EC TITLE: Removal of Electric Trap Primer Note
PROJECT: 3 Kings Water Treatment Plant

EC NO.: 60
DATE: 8/21/2020
STATUS: Open

DRAWING NO.: 300-P-2001 PLUMBING - FACILITY 300 -
AREA 310 - BWW CLARIFIERS - PLAN

VERIFY SCALE	
DATE	02/10/2020
PROJ	694342
DWG	300-P-2001
SHEET	689 of 911

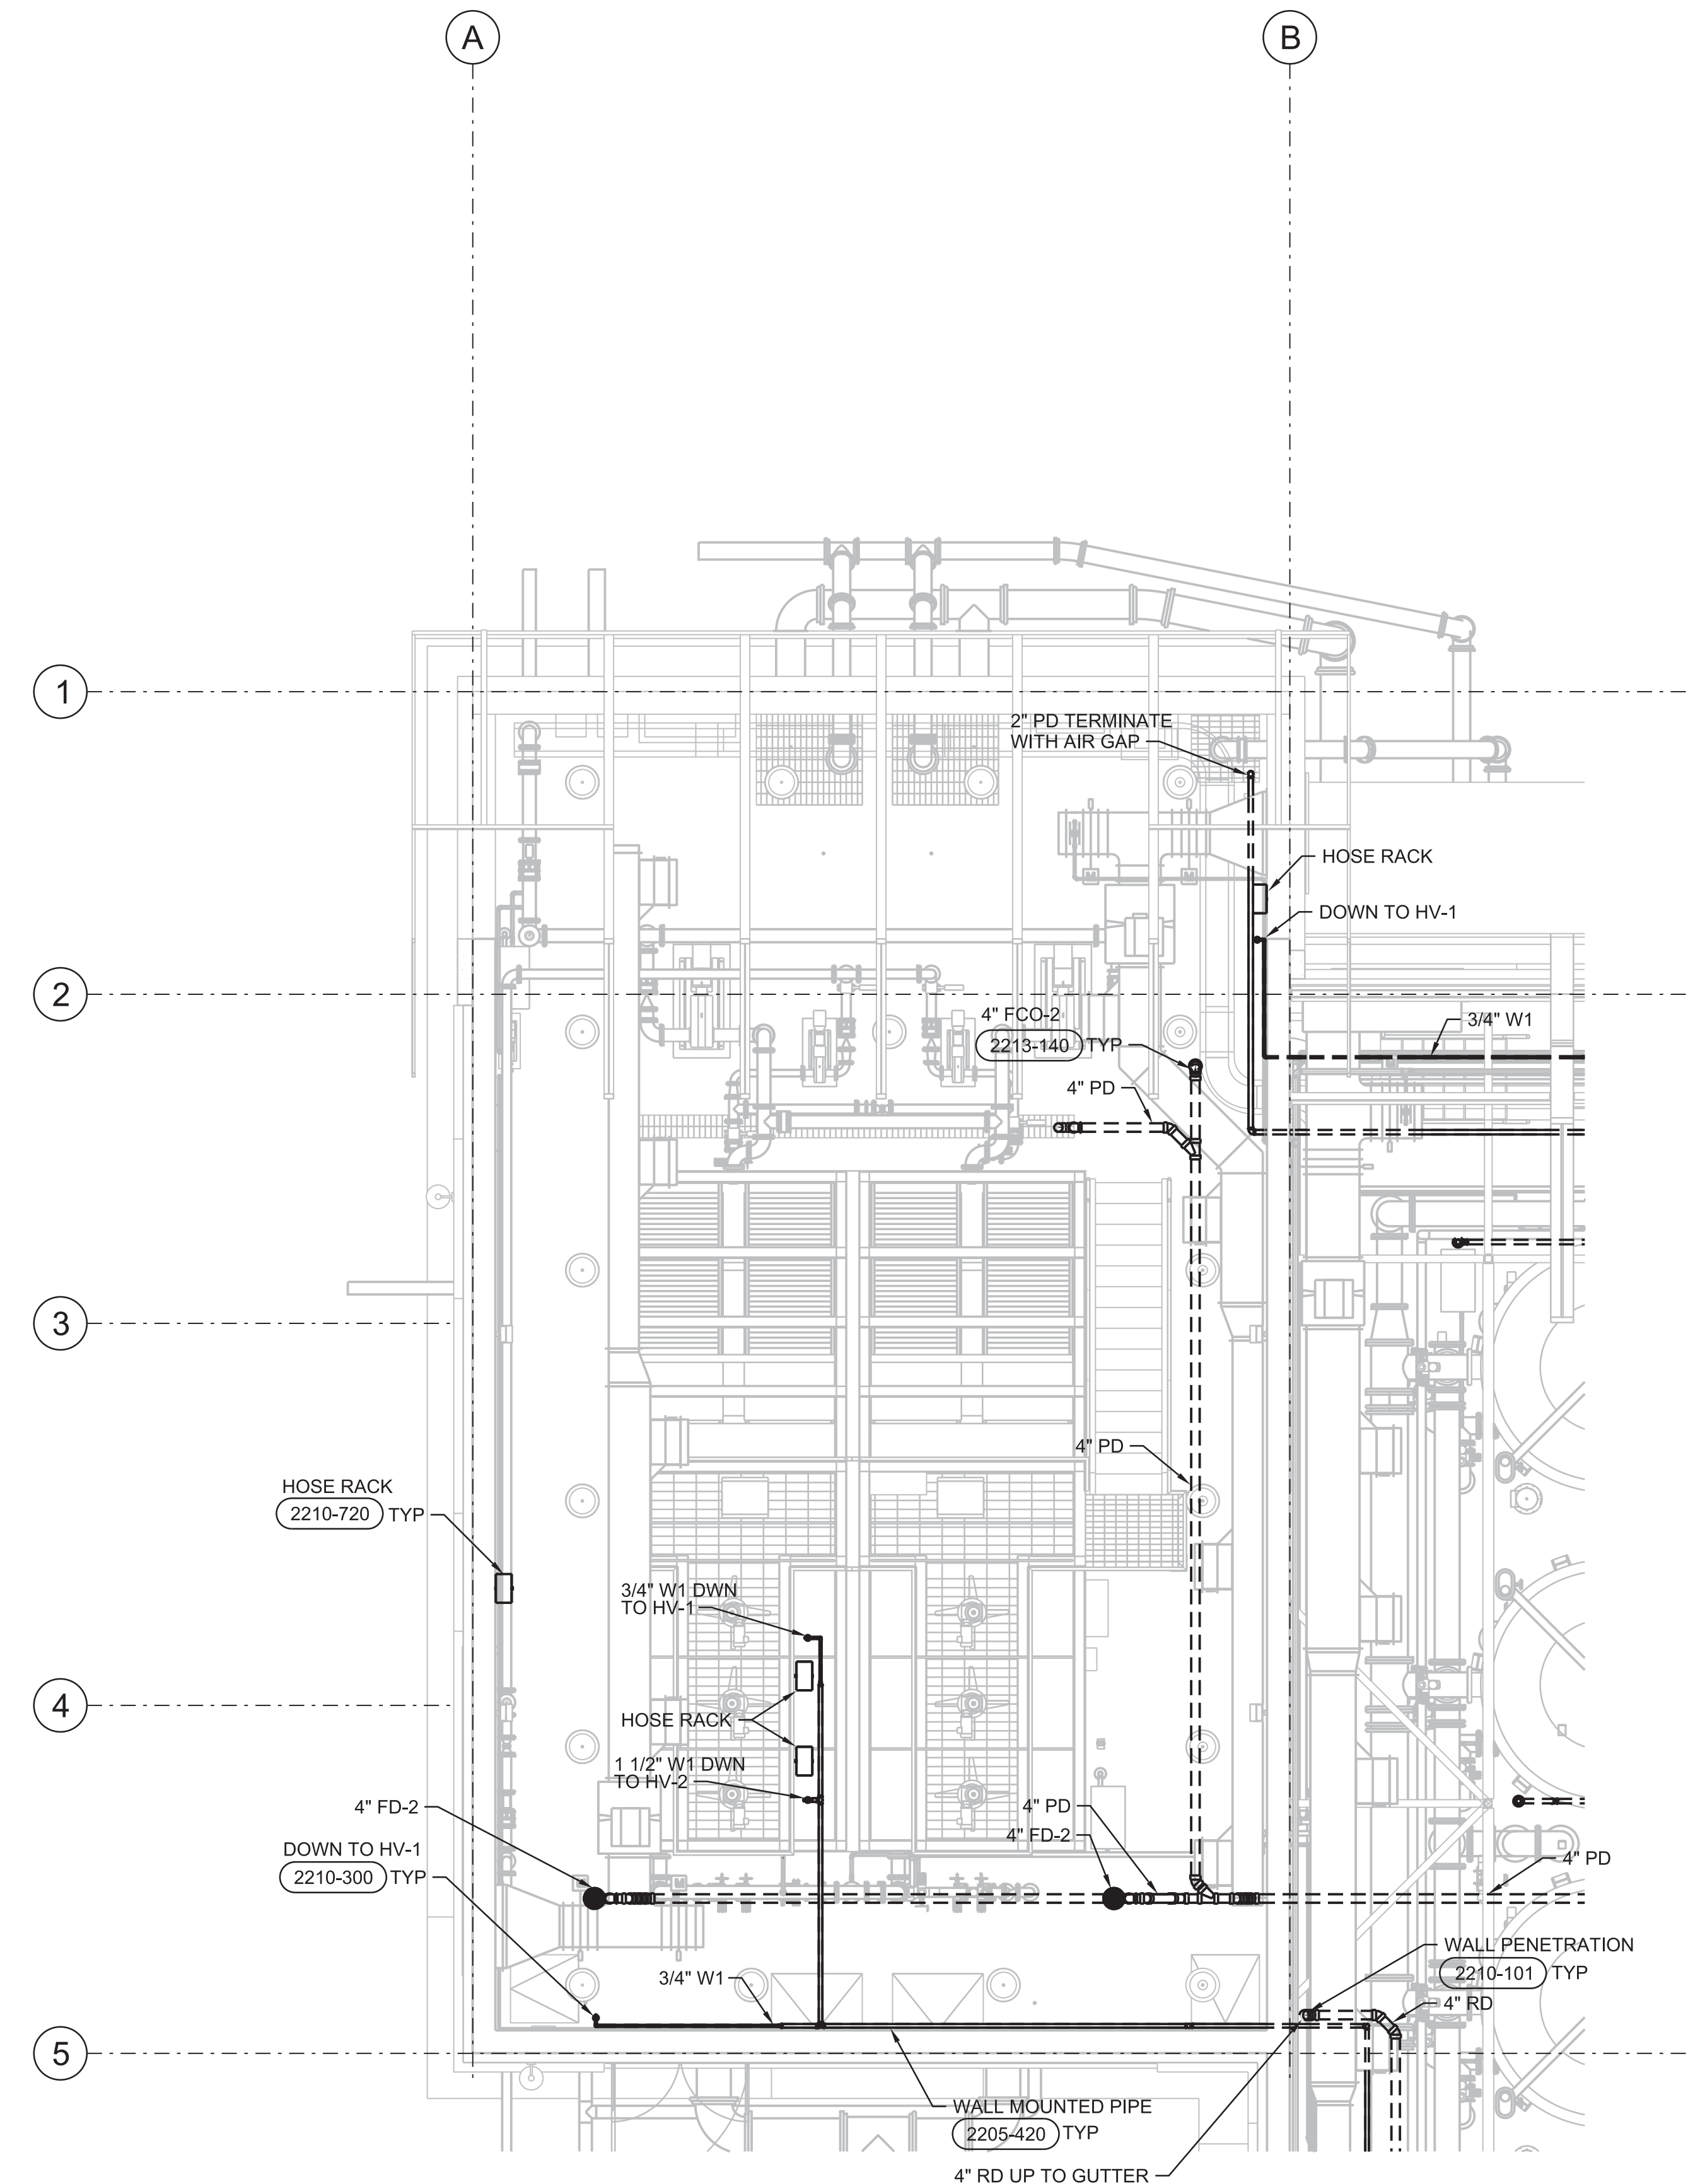
Note 1 on Dwg. 300-P-2001 is not necessary as there is no electric trap primer in this area.

See attached markups.
